SAN ANTONIO WATER SYSTEM
DSP Clayton Tank Replacement Project
SAWS Job No. 14-6101
Solicitation No. CO-00028

ADDENDUM NO. 5
November 5, 2015

The following changes, additions, and/or deletions are hereby made a part of the Contract Documents for the SAWS DSP Clayton Tank Replacement Project, for the San Antonio Water System, San Antonio, Texas, Dated October 2015, as fully and completely as if the same were set forth therein.

**SAN ANTONIO WATER SYSTEM
 DSP CLAYTON TANK REPLACEMENT PROJECT
 DOME SLEEVE LOCATION & DETAIL**

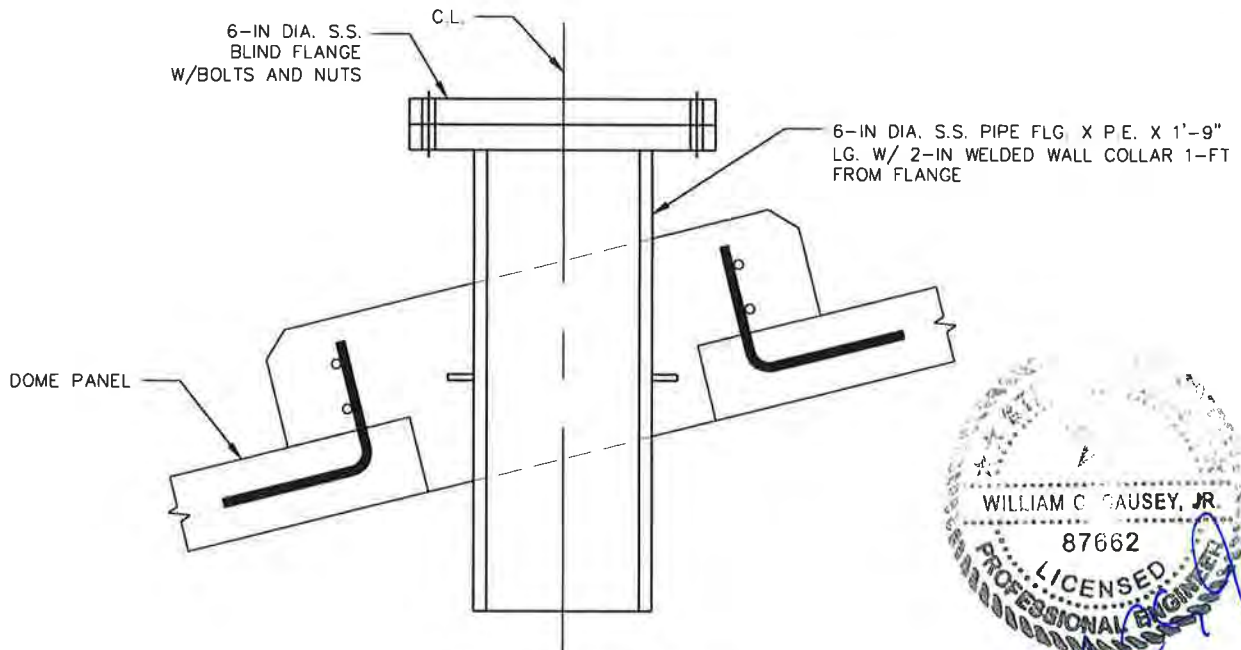
INCLUDE Exhibit D attached as part of Sheet T-SPS-1 for location and details on installing the tank roof dome sleeves for the level electrodes.

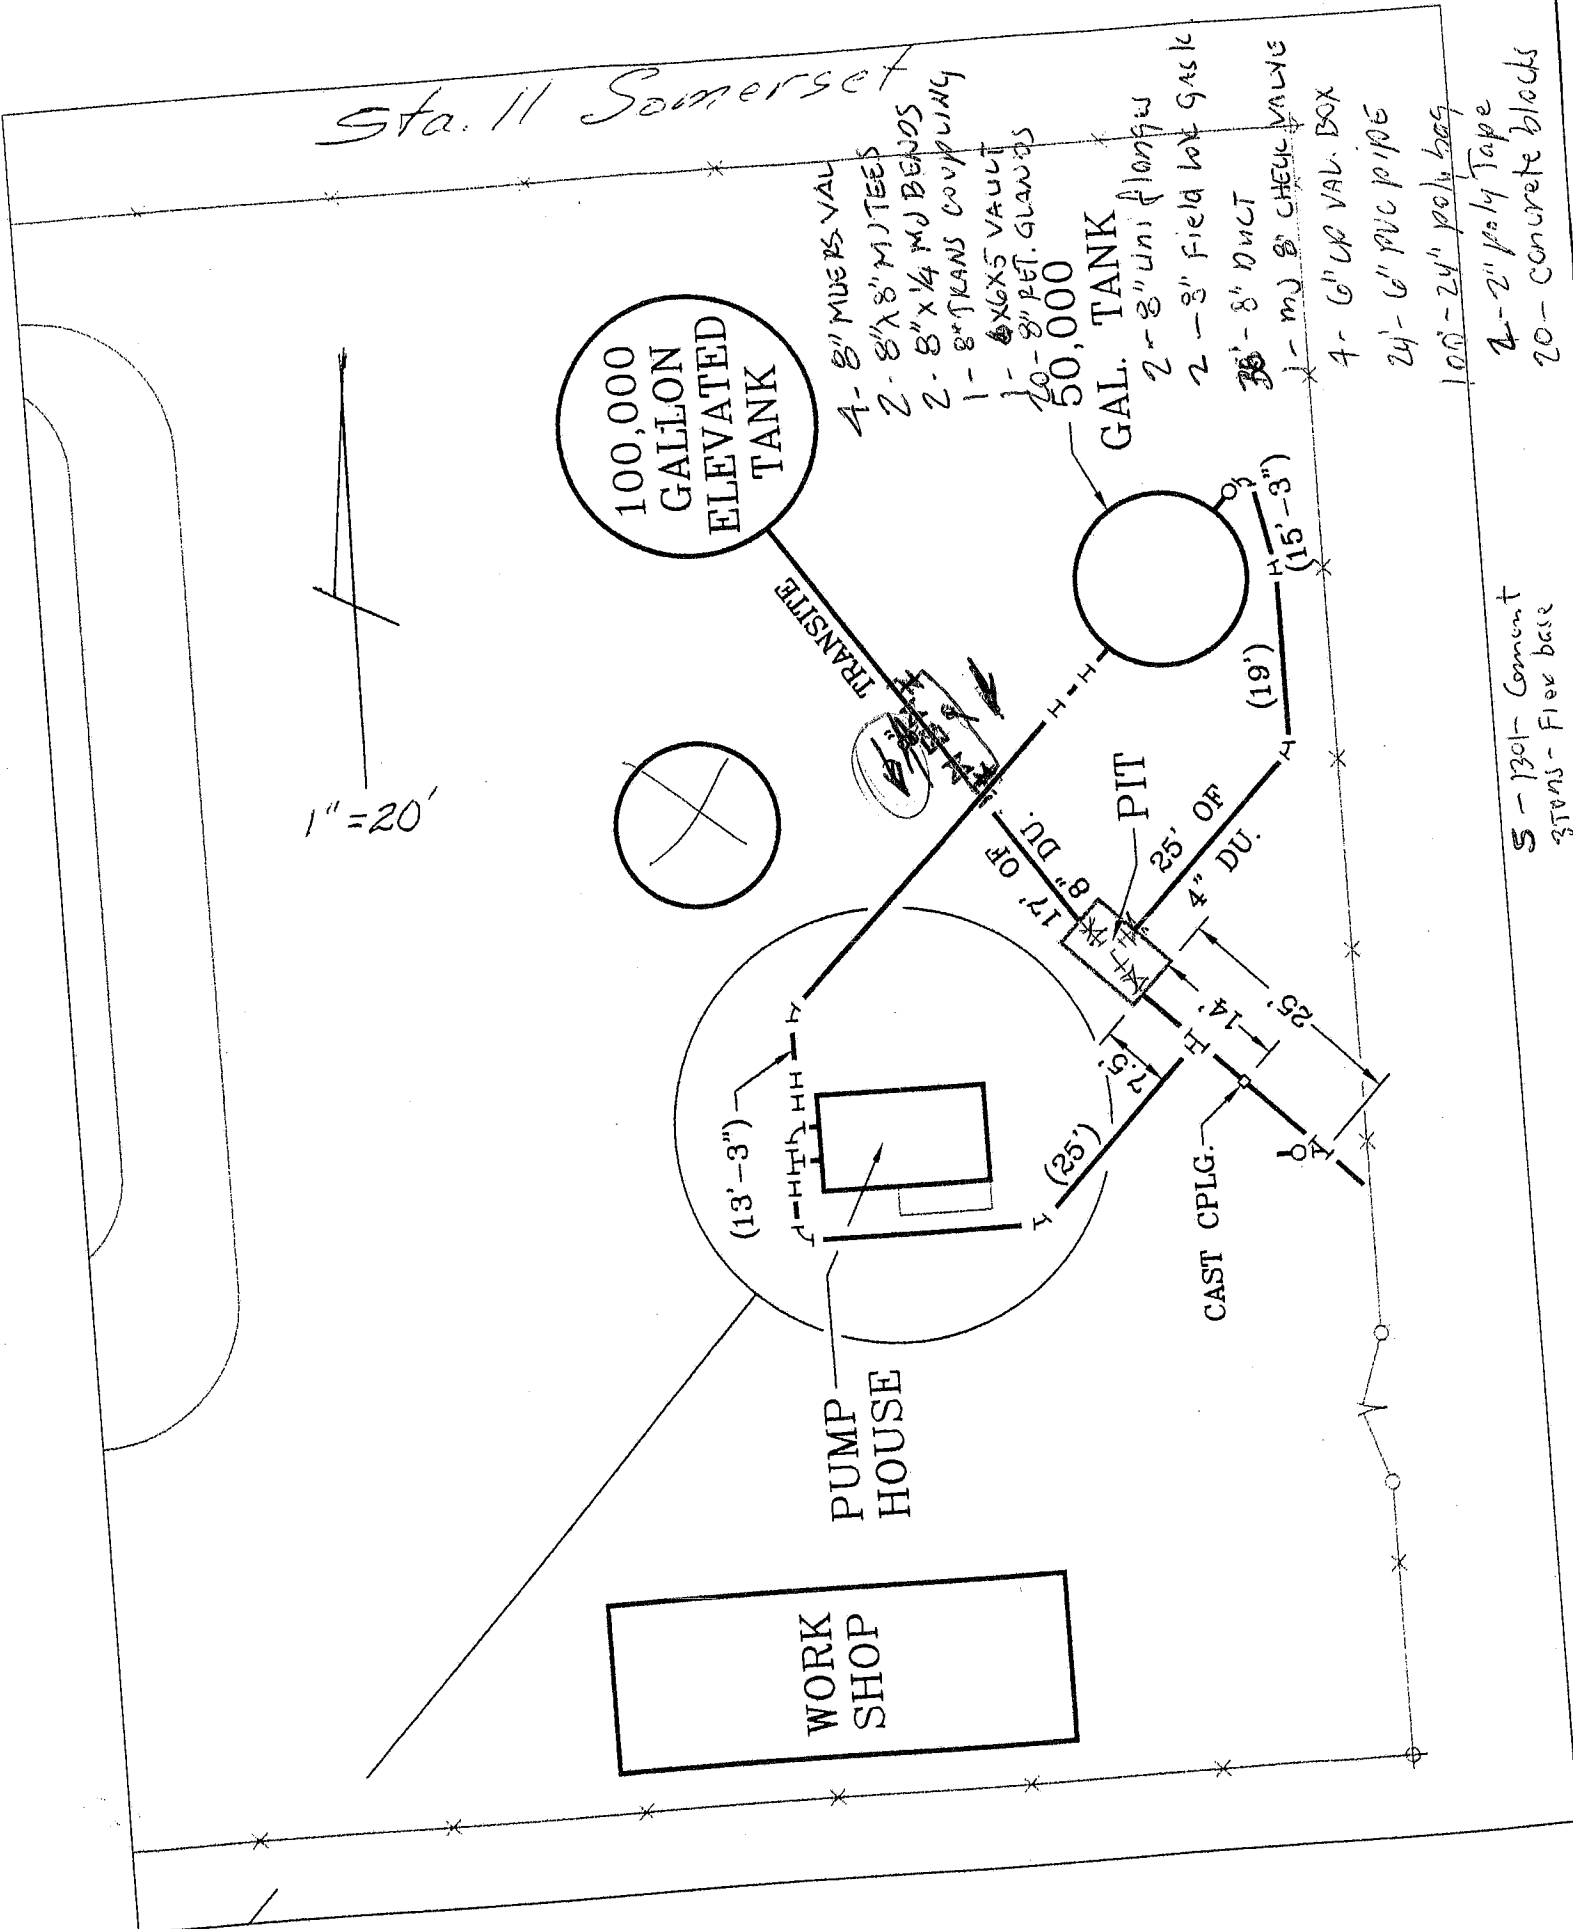
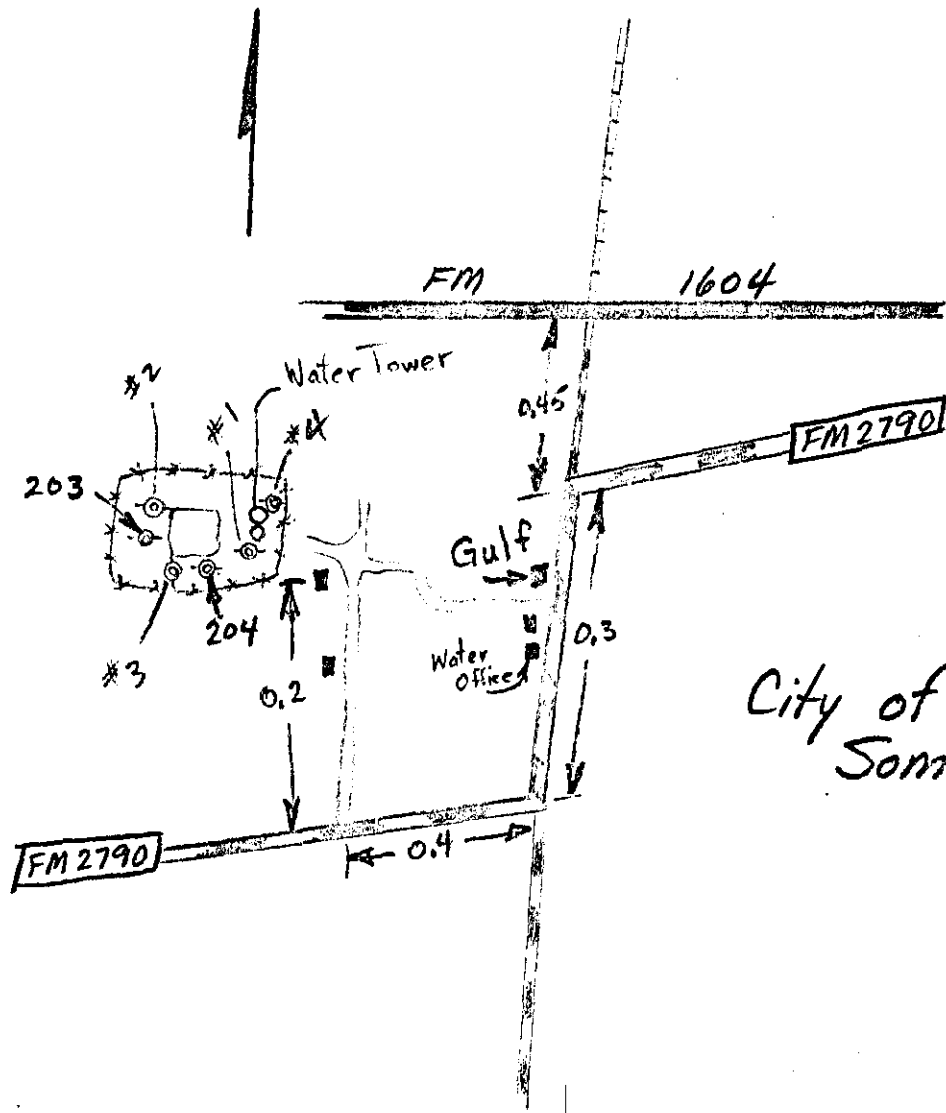
INCLUDE the attached Clayton Facility well data sheets for reference only.

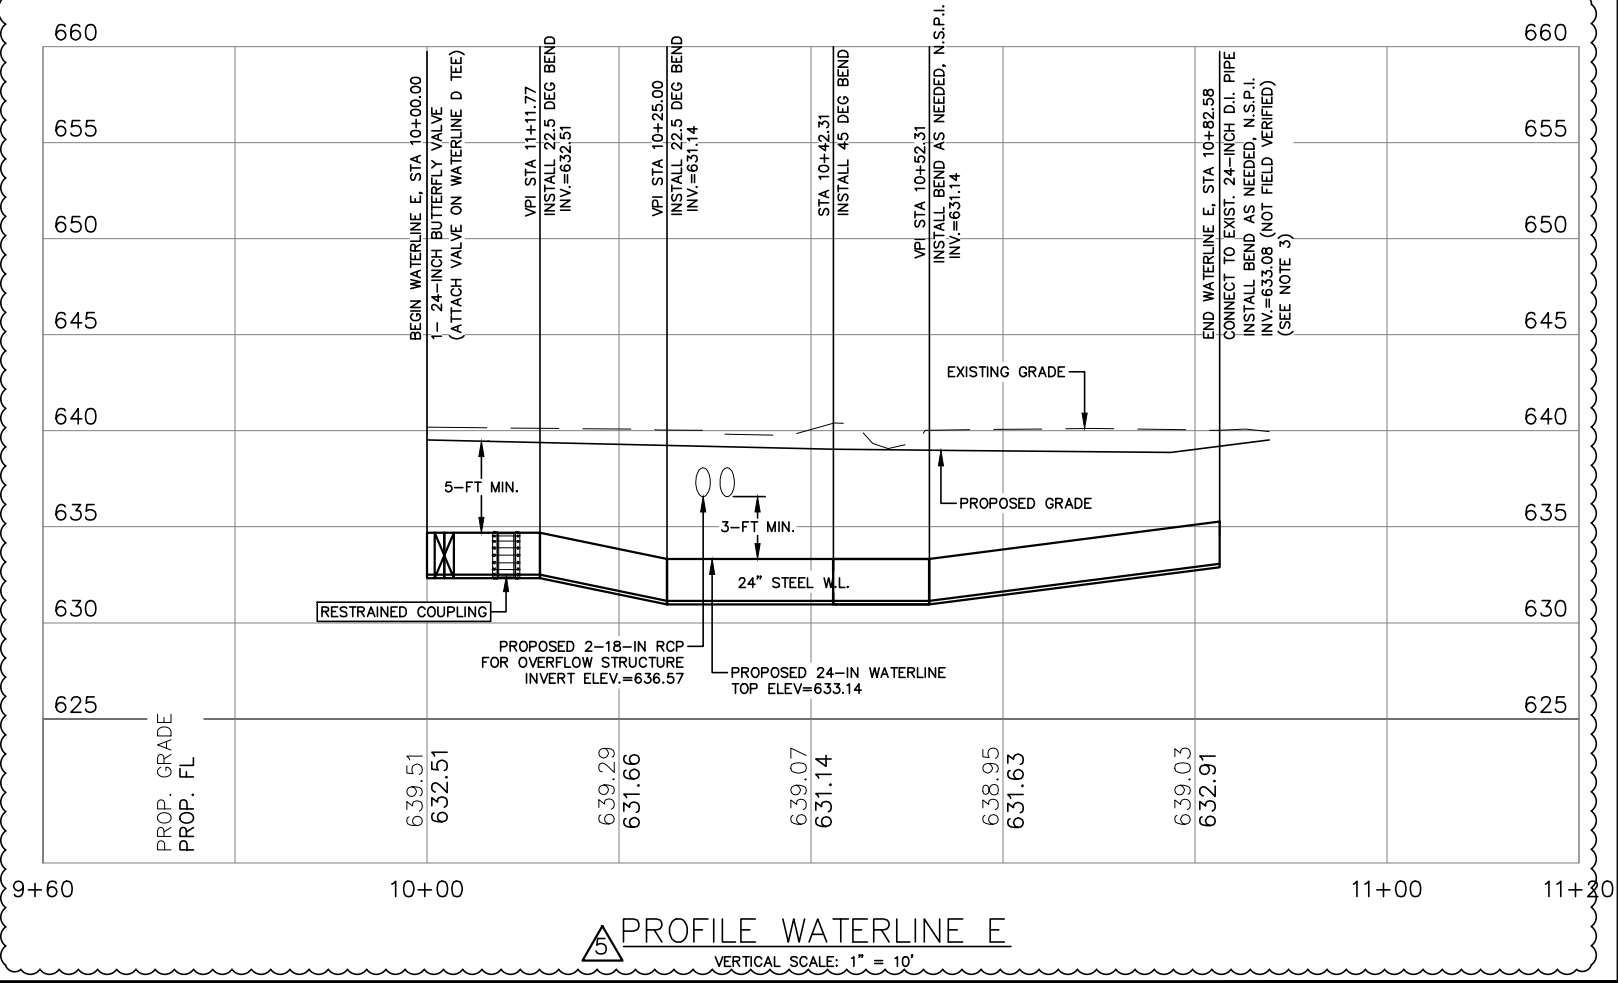
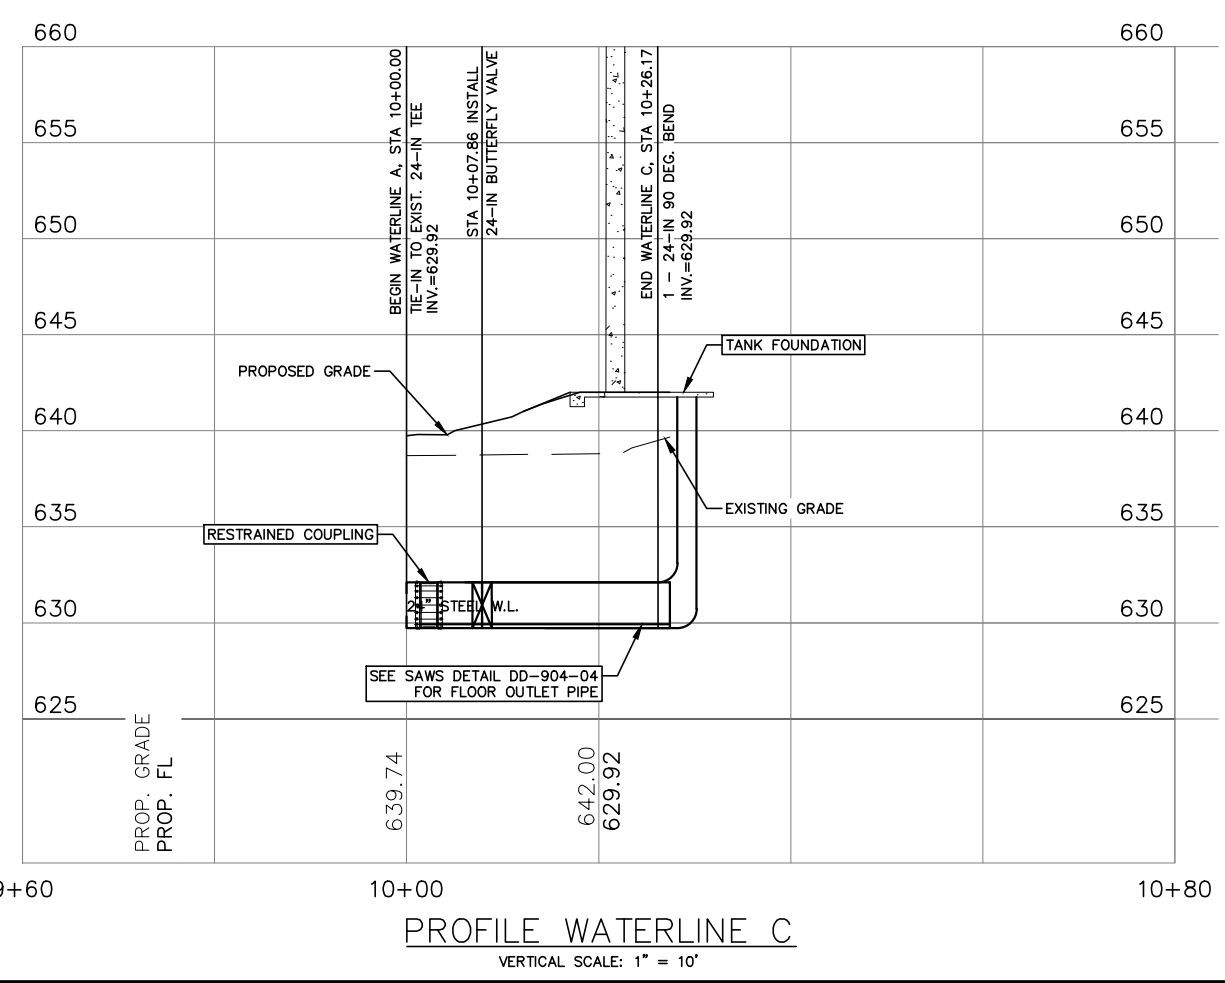
REMOVE AND REPLACE Sheet C-SPS-17 Proposed Yard Piping Plan & Profile III (Sheet 21 of 99) in its entirety with the attached sheet.

5	ADDENDUM NO. 5 P.E. SEAL DATE	11.04.2015	W.C.C.	11.04.2015					
5	REVISED WATERLINE E		W.C.C.	11.04.2015					
No.	Revision		Approved	Date
